# Service Bulletin

Ref. No. **COM-0218 (B056)**

<b>Subject</b>	<b>Note when releasing the paper jam/maintaining the machine (Prohibition of use of the flammable sprays and liquids)</b>
<b>Model</b>	All models

Subject	Parts Change Information
<b>Model</b>	TASKalfa500ci, TASKalfa400ci, TASKalfa300ci, TASKalfa250ci, TASKalfa552ci, TASKalfa420i, TASKalfa520i, TASKalfa300i, TASKalfa620, TASKalfa820, KM-C2520, KM-C3225, KM-C3232, KM-C2525E, KM-C3225E, KM-C3232E, KM-C4035E, TASKalfa550c, TASKalfa650c, TASKalfa750c, KM-6030, KM-8030, FS-C8100DN, EP C320DN, FS-C8500DN, FS-C2026MFP, FS-C2126MFP, FS-3040MFP, FS-3140MFP, DP-700, DP-750/DP-750(B), DP-760/DP-760(B), AK-470

**<Assembly Process Improvement → After using up the old stock>**

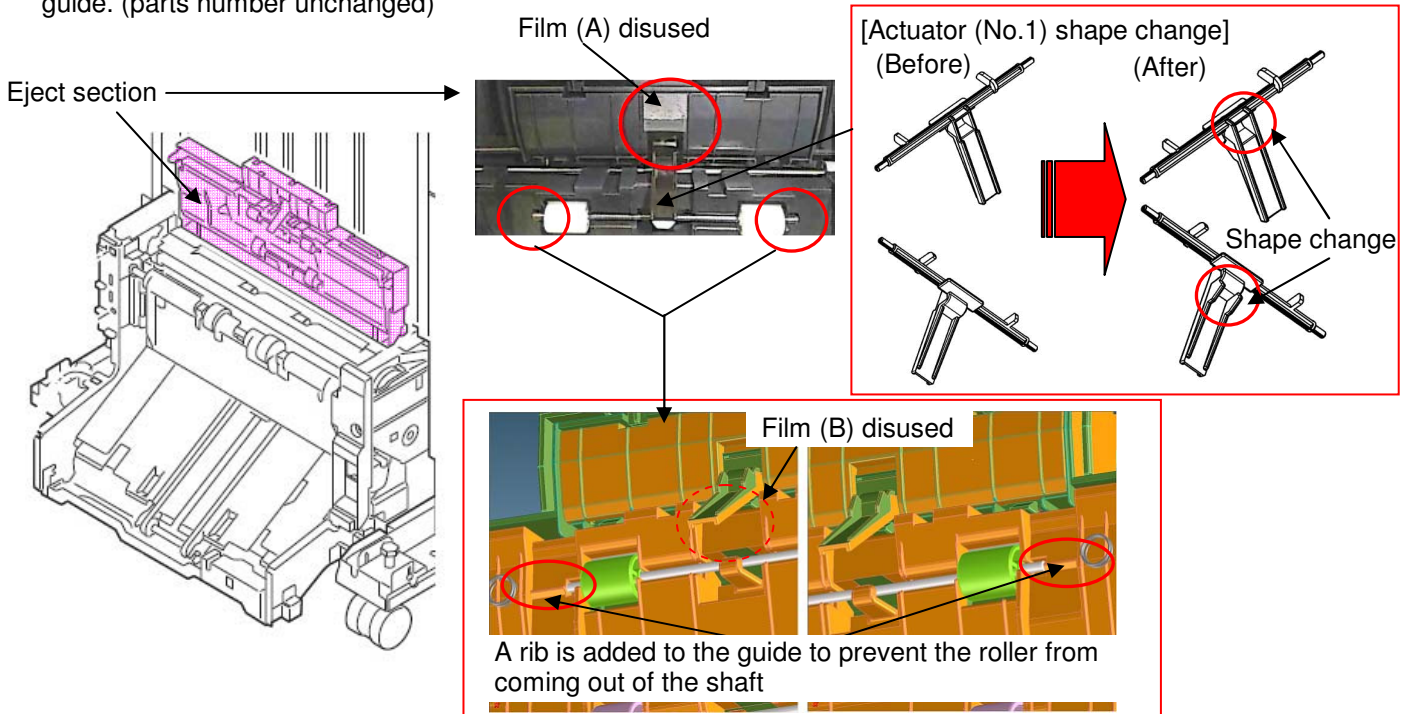
The eject section is changed as below to improve the assemble process.

**<The pick-up holder torque limiter attached (DP section) → After using up the old stock>**

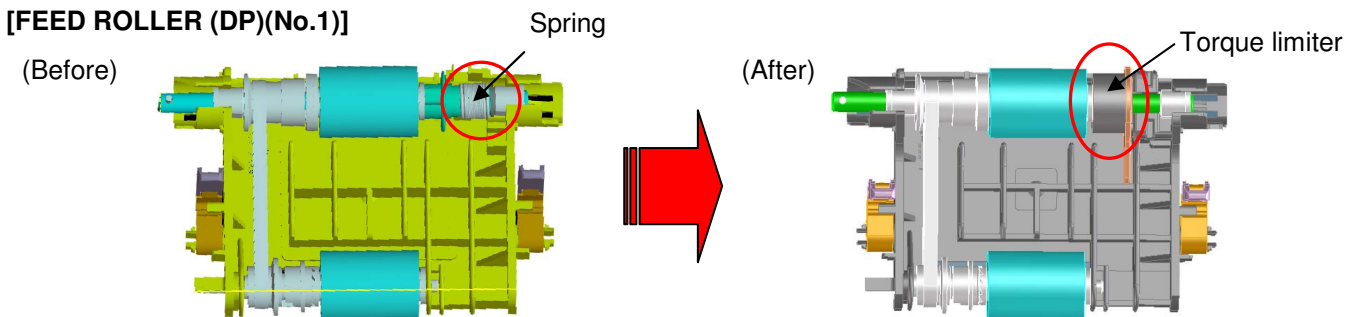
The spring is changed to the torque limiter to improve the margin for the DP pick-up holder elevation motion.

**--> After using up the old stock>**

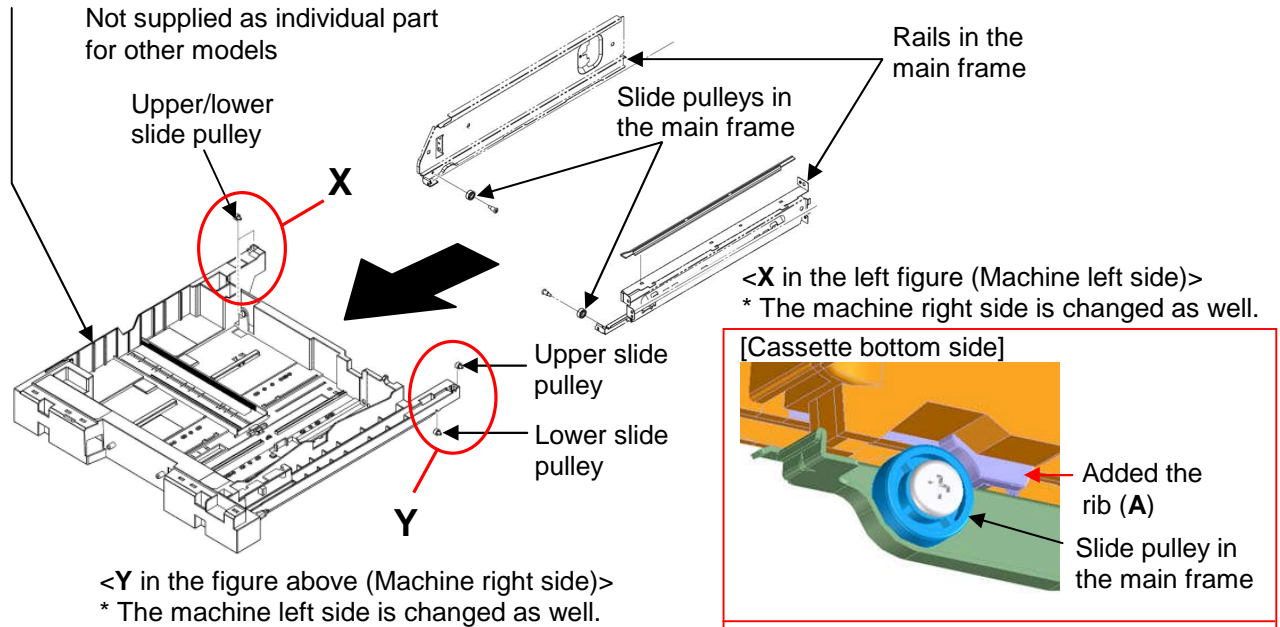
The shape of the cassette is changed as below to improve the operability when pulling out the cassette.
